**From:** Christian Smith [REDACTED]  
**Sent:** 27 September 2023 10:27  
**To:** James Neave  
**Cc:** Andrew Sierakowski; Kirstie May  
**Subject:** RE: Elbridge Farm - Further information required - JN to Agent 31 07 23  
**Attachments:** 3419\_WSCC flooding & drainage (LLFA) HW comments (04-09-23).pdf; GPP-RS-BR-EXT-22-02 v17 Site Layout Plan\_20092023\_A2.pdf

**From:** James Neave <James.Neave@westsussex.gov.uk>  
**Sent:** Monday, July 31, 2023 2:06 PM  
**To:** Christian Smith [REDACTED]  
**Cc:** [REDACTED]  
**Subject:** Elbridge Farm - Further information required - JN to Agent 31 07 23

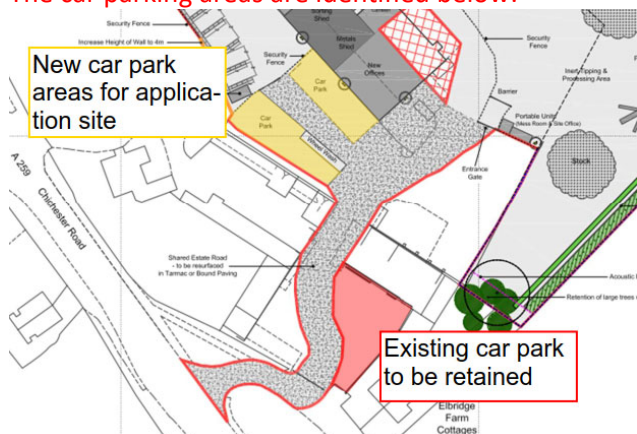
- Please see the comments of the WSCC Arboriculturist that will need to be addressed. In addition, of particular note is the potential impact of new fencing on existing trees to the rear of Elbridge Farm Cottages. Given the apparent space available in this location, consideration should be given to providing a greater standoff. Further, there may be added benefit of dog-legging the permitter bund in this location which may remove the need for separate acoustic fencing and reinforce screening of the proposed extension area. To be explored by the applicant. **Please see attached the amended Site Layout Plan (v17), which proposes a stand-off from the existing trees to the rear of Elbridge Farm Cottages. Heras fencing will be secured before construction works commence to ensure that the existing trees are protected (RPZ and canopy's). The Applicant would be happy to accept a pre-commencement planning condition covering details of this and the suggested five-year aftercare management plan.**
